## VR-26-02

**VR-26-02 (HEB Parking Location Variance)** Consider approval of Resolution 2026-XX, approving a variance from the parking requirements applicable in the Whisper Planned Development District to allow for 16 rows of parking within the first layer along IH-35 Frontage Road and 4 rows of parking along Yarrington Road for an approximately 22-acre portion of the Development bounded by IH-35 Frontage Road and Yarrington Road; and declaring an effective date.

HEB Parking Location Variance

# Site Plan

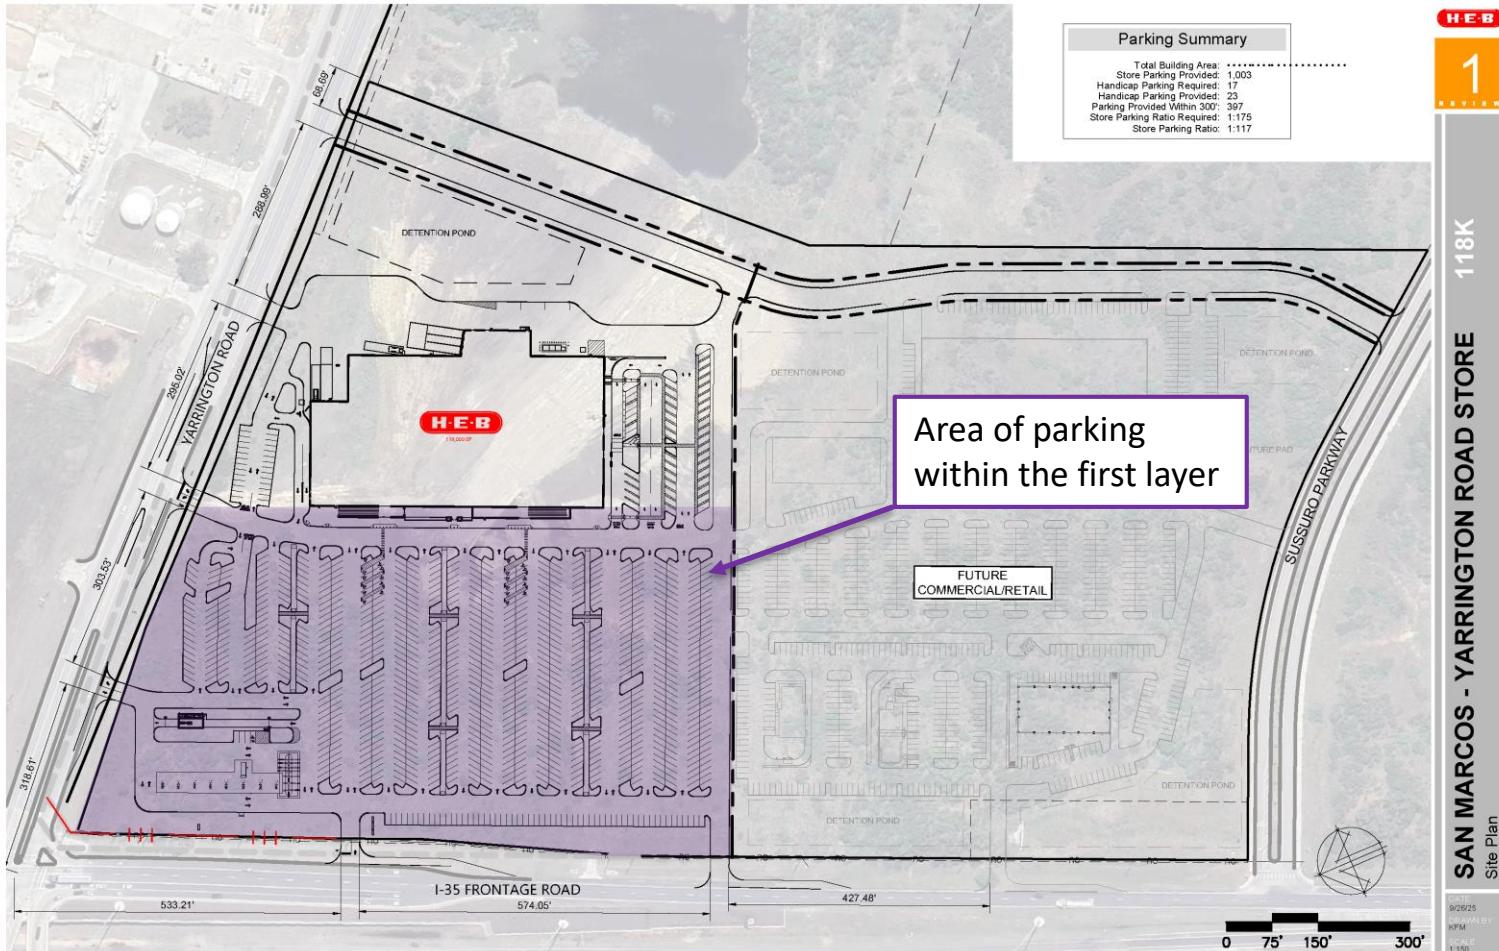
- PDD allows for 1 row of parking in the first layer
- Applicant is requesting 16 rows of parking within the first layer along IH-35 Frontage Rd and 4 rows of parking along Yarrington Road.

Staff recommends approval of the request with the following conditions;

1. The subject property shall provide over detention of site runoff to 90% of existing flows;
2. Parking lot landscaping shall be provided in accordance with Section 7.1.4.3 of the current Land Development Code in effect on February 3, 2026;
3. Electric vehicle charging stations shall be provided on the subject property; and
4. The applicant has agreed to apply the following building materials criteria in the event this variance is granted. The primary structure shall meet or exceed the Whisper PDD, Division 7, Durable Building Material Area requirements as follows:
  - A minimum of 80-90% of Primary Materials shall be provided;
  - A minimum of 5-15% of Secondary Materials shall be provided; and
  - Up to 10% of Alternative Materials may be utilized. Alternative Materials may be proposed by the applicant at the time of building permit. [sanmarcostx.gov](http://sanmarcostx.gov)
